Re: Indian Point Units No. 2 and 3  
Docket No. 50-247 and 50-286  
NL-04-104

**SUBJECT: Reply to RAI regarding Relaxation Requests for Inspection of  
Reactor Pressure Vessel Head per NRC First Revised Order, EA-03-009**

**ATTACHMENT 1 TO NL-04-104**

**REPLY TO NRC REQUEST FOR ADDITIONAL INFORMATION REGARDING  
RELAXATION REQUESTS FOR INSPECTION  
OF REACTOR PRESSURE VESSEL HEADS**

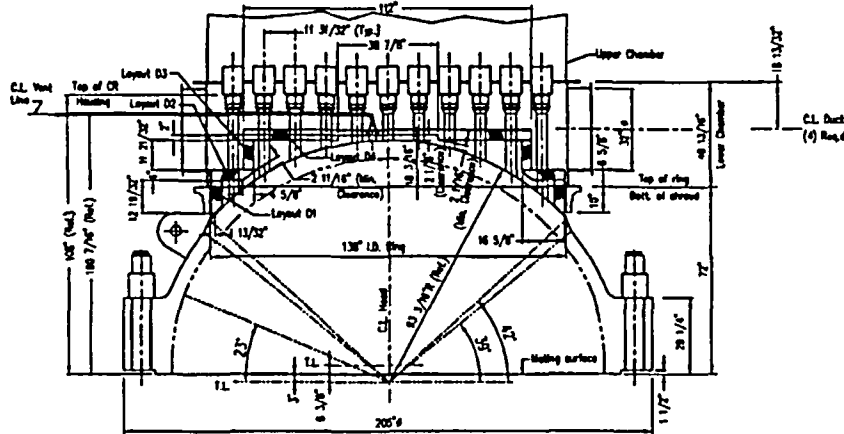
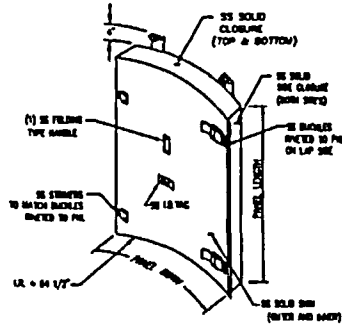
The licensee stated that, although the reflective metal insulation support ring is removable, the other components of the insulation package supported by the support ring and the control rod drive mechanism cooling shroud would have to be removed first to achieve a 100 percent bare metal visual coverage of the RPV head.

Provide a detailed discussion that identifies the difficulties in removing the insulation, including the other components that would need to be removed. Provide sketches to show all the components that need to be removed in order to achieve a 100 percent bare metal coverage. Discuss any unique challenges posed by the removal of these components.

Removal of the reflective metal insulation (RMI) support ring is a challenging labor and dose intensive task. Based on experience gained in refueling outages 2R15 (Fall 2002) and 3R12 (Spring 2003) this work would take approximately 2500 man-hours and result in an estimated additional personnel exposure of 7 person-rem for Unit 2 and 3.5 person-rem for Unit 3. The primary steps for removal and replacement of the insulation are listed below.

1. Build scaffolding around the Reactor Pressure Vessel (RPV) Head.
2. Unbolt CRDM cooling shroud bolts. (18 bolts at the base of the shroud support ring).
3. Install rigging.
4. Lift the shroud approximately 4 feet high. Maintain it raised for entire evolution.
5. Establish laydown area for insulation panels.
6. Remove 18 insulation top panels.
7. Remove 24 top-side insulation panels.
8. Remove 24 lower-ring insulation panels.
9. Remove 24 support ring insulation panels.
10. Reverse sequence for re-installation of the entire insulation support package.

The RMI support ring insulation panels (item D1 on attached drawing) rest on the RPV head, downslope of the outermost penetration nozzles. This ring provides structural support for the entire insulation package. The RPV head surface obscured by this support ring is calculated at less than 5%, with inspection access from the upslope and downslope sides. Therefore the planned inspection will cover at least 95% of the RPV head surface. The attached drawing is typical for Indian Point 2 and Indian Point 3.

Removal of the entire insulation support package, as identified above, is a labor intensive activity and the additional stay-times by personnel in the radiation field required to perform the removal and re-installation task represents a hardship without a compensating increase in the effectiveness of the bare metal visual examination. However, if evidence of boron or corrosive product is identified under the RMI support ring, the examination will be expanded to cover the affected area under the interference.
